| Project Title: | Carlsbad Energy Center - Compliance |
| Document Title: | Project Owner's Responses to Data Requests in Set One (Nos. 1-30) |

Re: Carlsbad Energy Center Project Petition to Amend (07-AFC-06C)
Project Owner's Responses to Data Requests in Set One (Nos. 1 - 30)

Data Response Set 1 (Responses to Data Requests 1 to 30)

| DRAWN BY: DOP | ENCINA POWER STATION FIGURE TSE1c-4 T-LINE POLE CROSS SECTION | | |

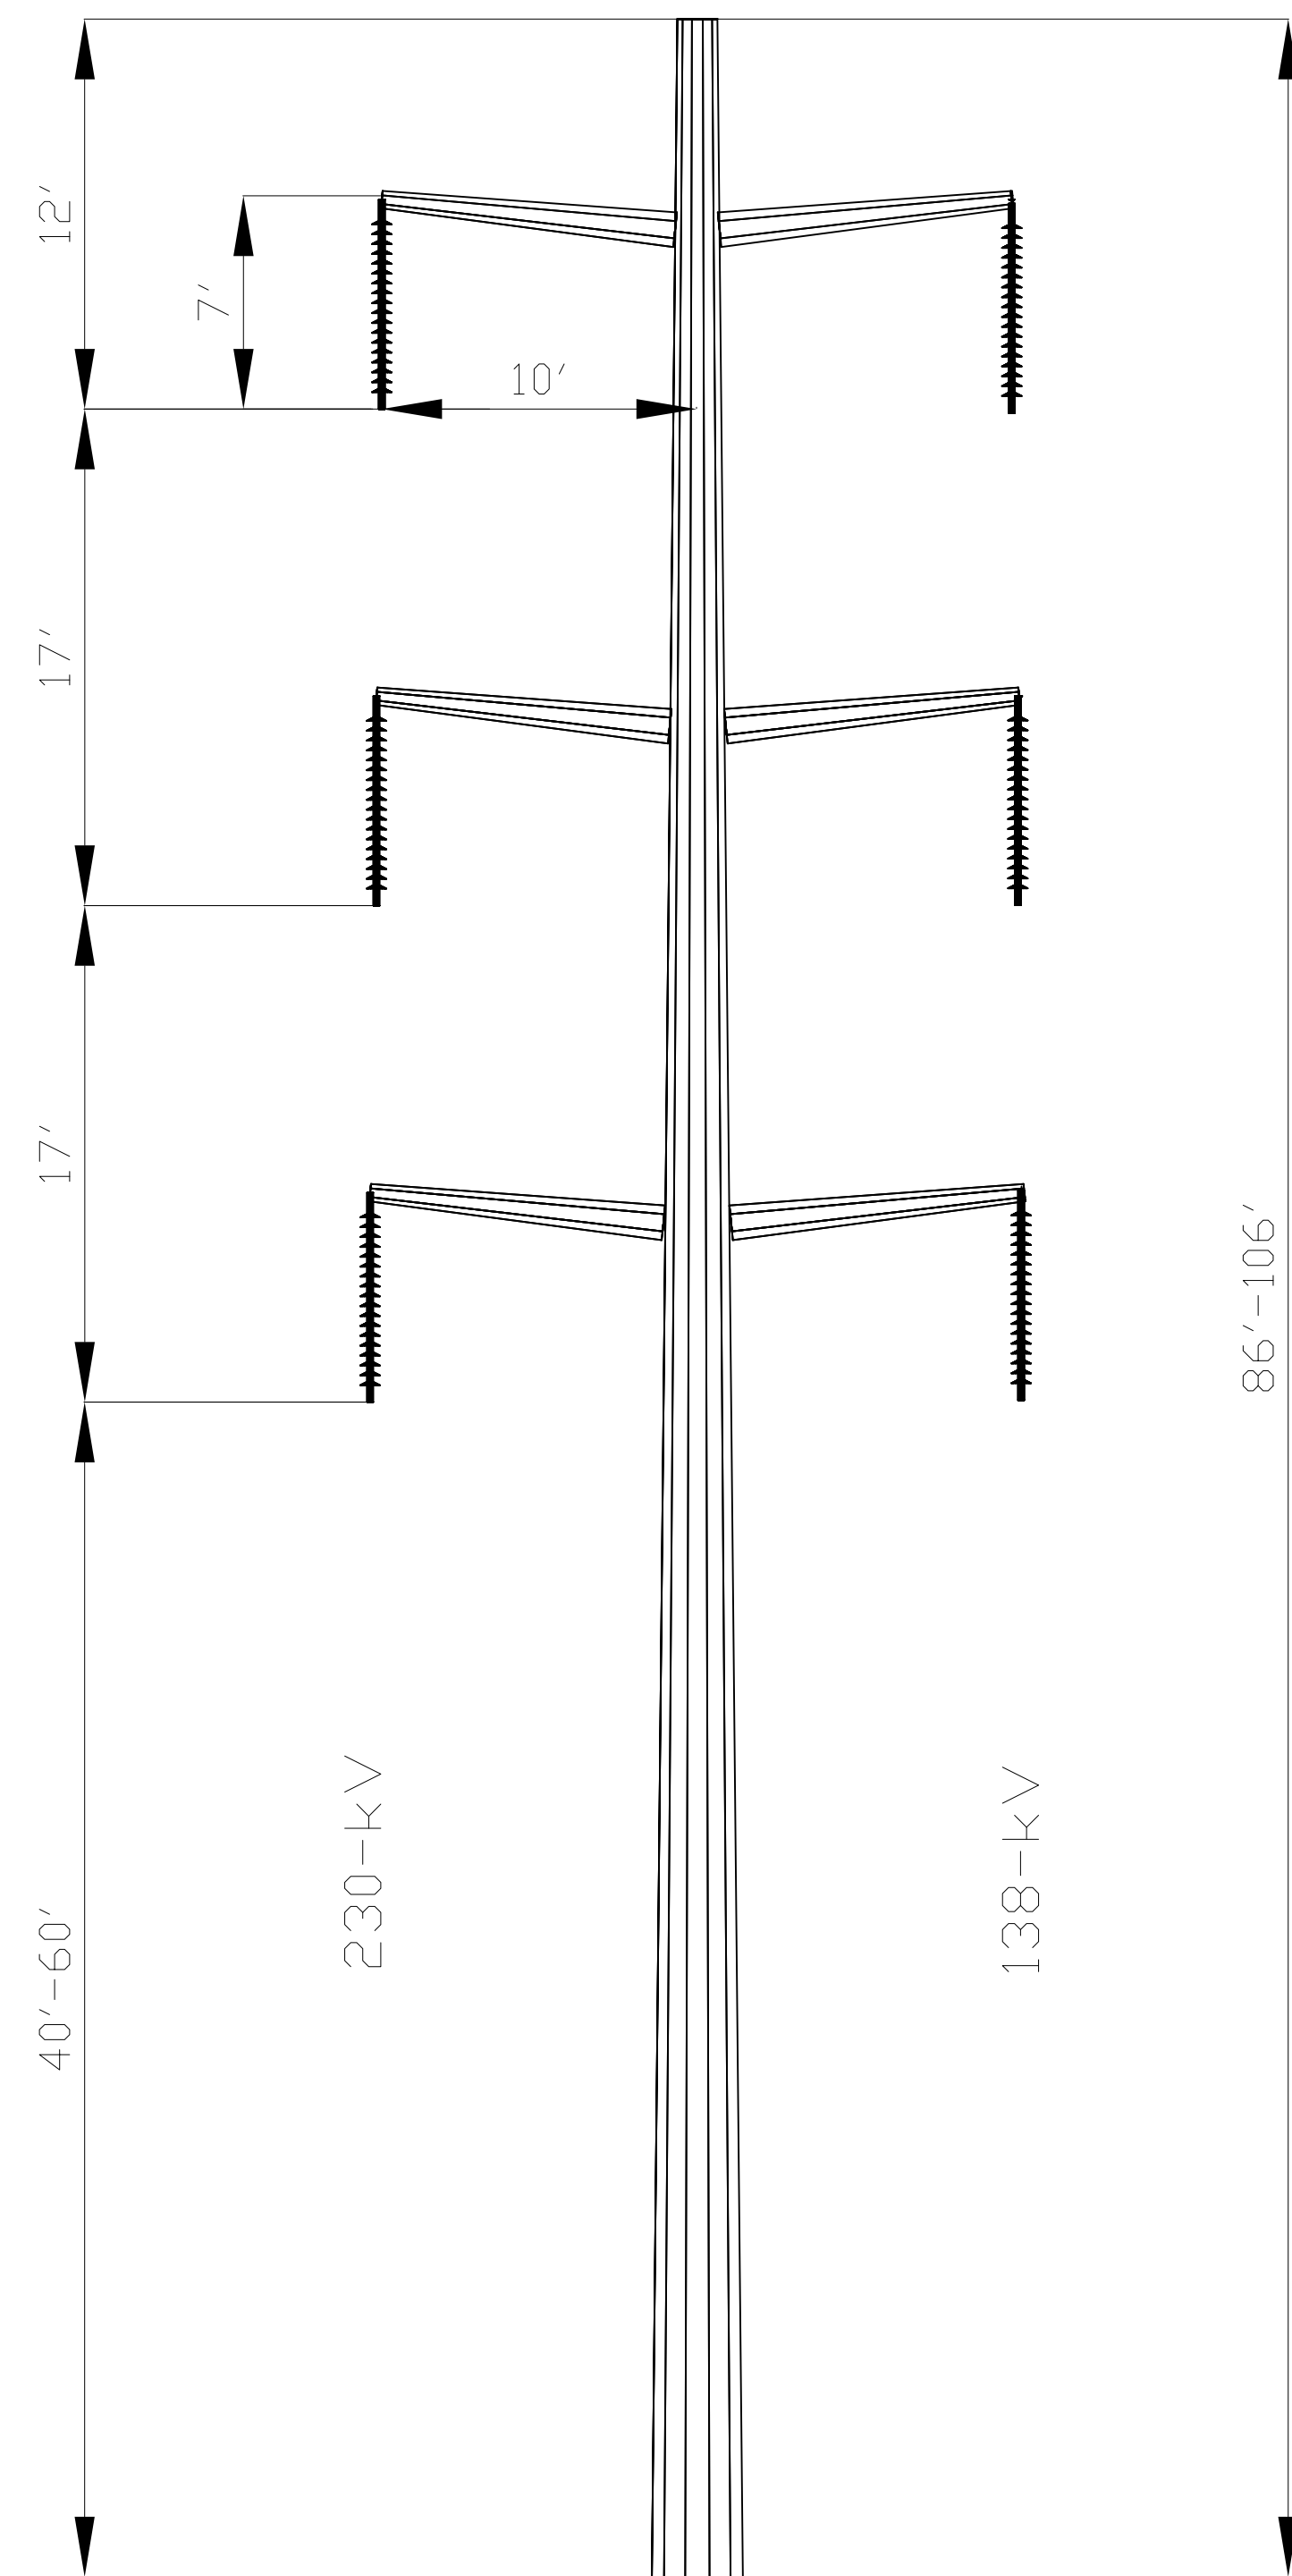
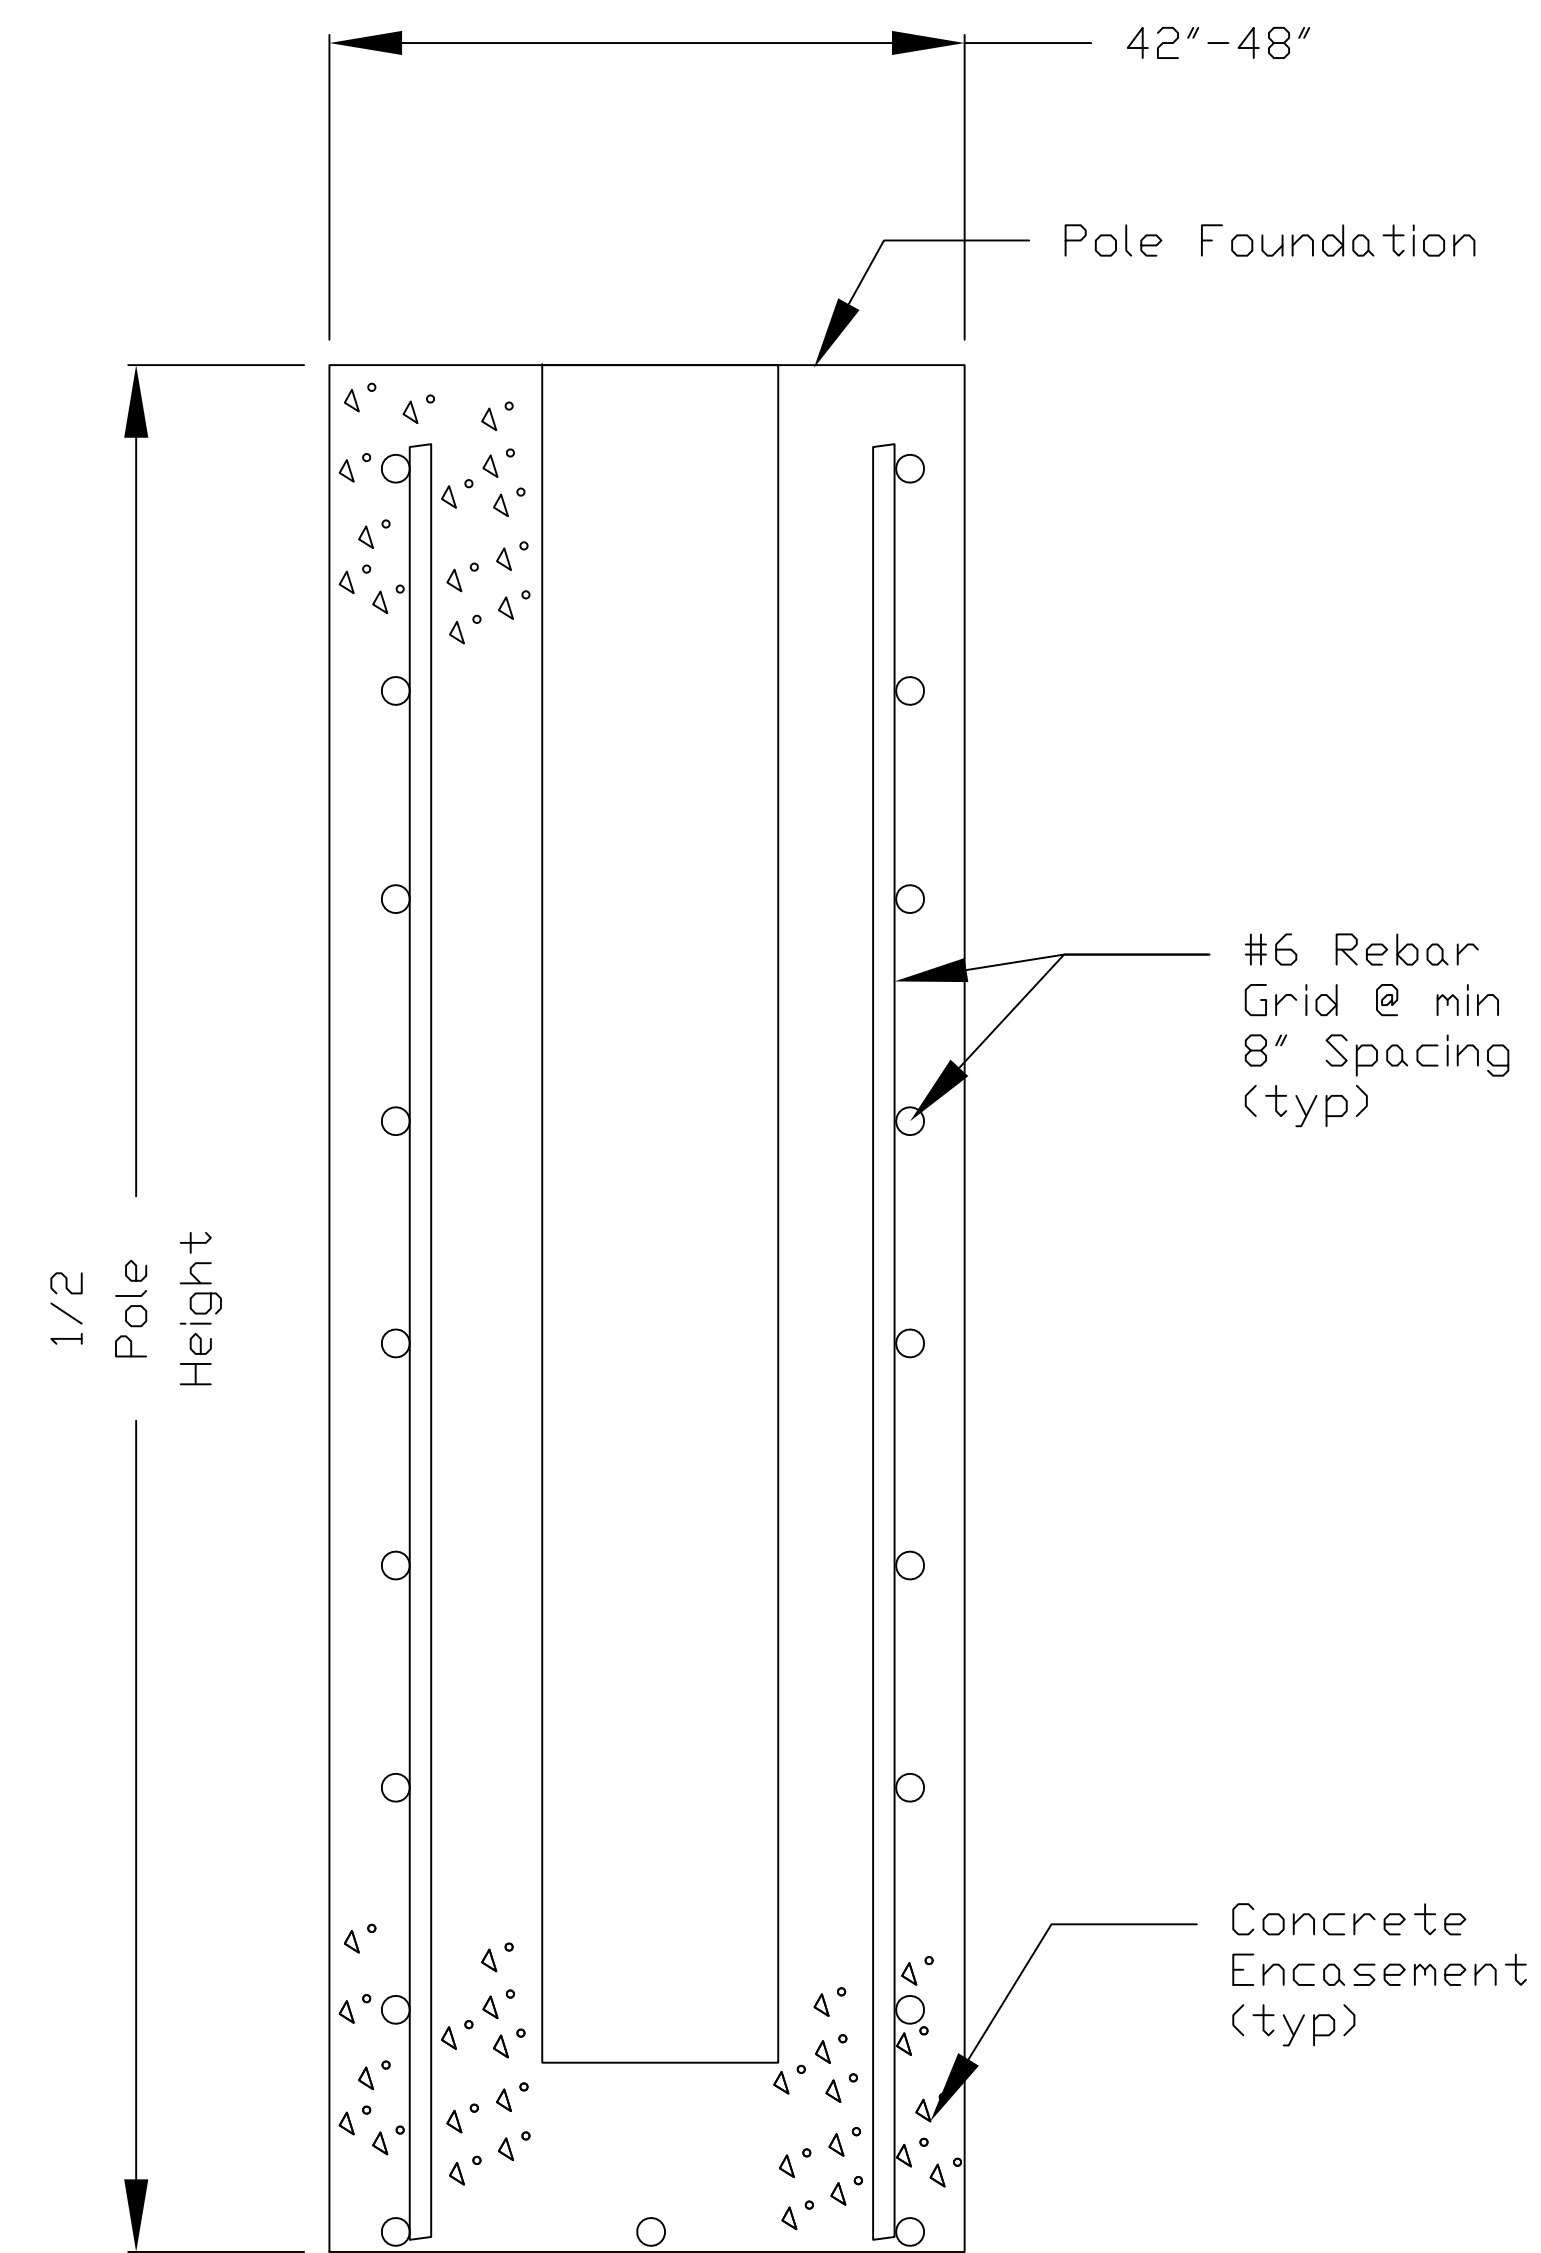
24. Resubmit 138 kV single line dead-end pole diagram (Figure 3.1-5) and 230/138 kV double circuit tangent and dead-end pole diagrams (Figures 3.1-6 & 3.1-7) design diagrams stating type of the pole(s) (steel or wood or any other), length of the insulators, and size & type of overhead conductors. Please show the height of the poles below and above the ground level, conductor-position measurements for the 230 kV and/or 138 kV side of the pole, and between conductors of both sides. Also show and describe any ground conductors, including their size, and provide the ground clearance distance from the lowest conductor on the pole.

Project Owner hereby submits revised versions of the pole drawings that were submitted in the PTA , containing additional information. These are Figures DR24-1 (corresponding to PTA Figure 3.1-5), DR24-2 (PTA Figure 3.1-6), and DR24-3 (PTA Figure 3.1-7). Overhead conductor sizes are shown on Figure DR22-2.

Response: As noted in Project Owner's objection to this Data Request, 138 kV single line tangent poles are not required in the current design of the transmission line and diagrams of them will not be submitted. 138kV/230kV double-circuit poles will be used instead, and Project Owner has included a diagram of this pole type as Figures DR24-2 and DR24-3 below.
